PRIMROSE DAYCARE AND SWIM SCHOOL JSP22-53

Public Hearing at the request of EIG14T (Eight-Fourteen) NOVI MI LLC for approval of the Preliminary Site Plan, Special Land Use Permit, Stormwater Management Plan, and Woodland Permit. The subject property is approximately 5.59 acres. It is located south of Ten Mile Road on the west side of Novi Road, and it is in the OS-1 Office Service District. The applicant is proposing to demolish the existing building in the eastern portion of the site to build a 13,586 square foot daycare center and a 6,658 square foot swim school facility.

PLANNING REVIEW

SHEET
OVERALL PLAN

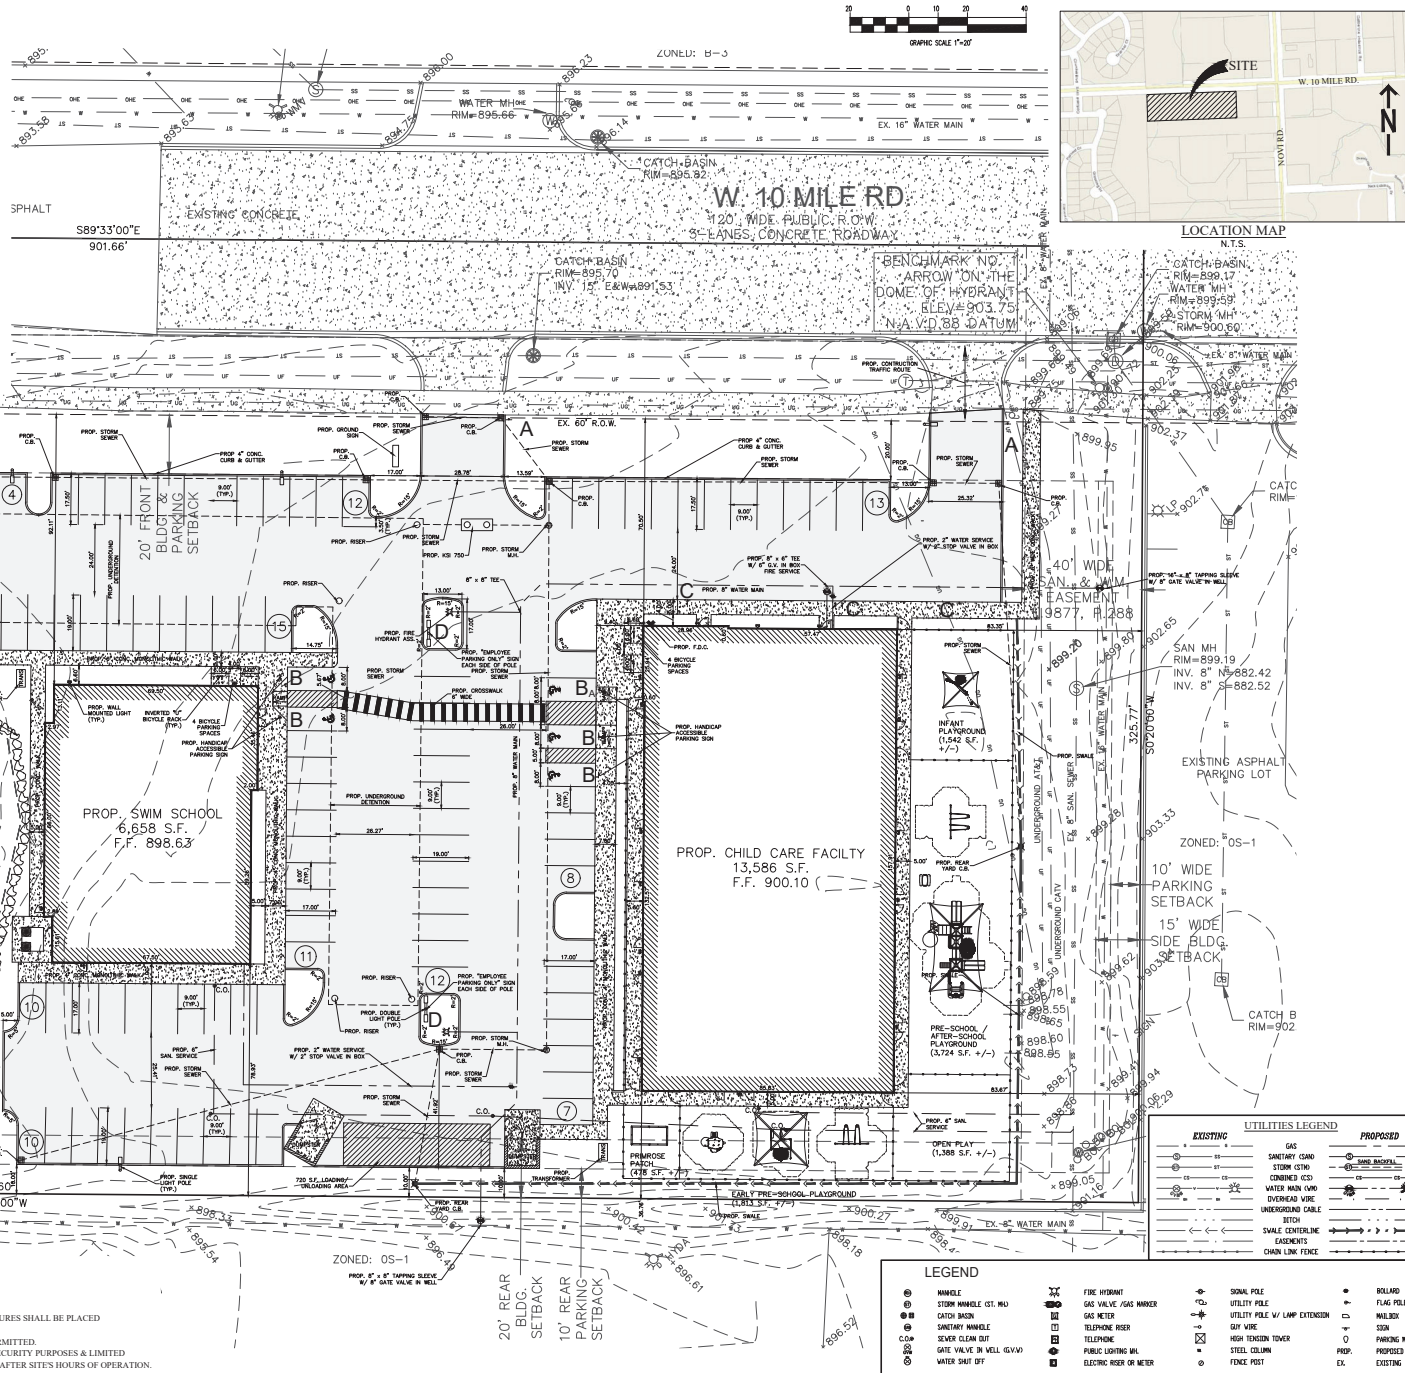
- **142 members / 4 = approx. 36 (listed incorrectly at 38 on sheet SP-2)**
 - **Number of spaces for daycare is correct, but the equation is listed incorrectly (should be listed as divided by 350 rather than 250)**
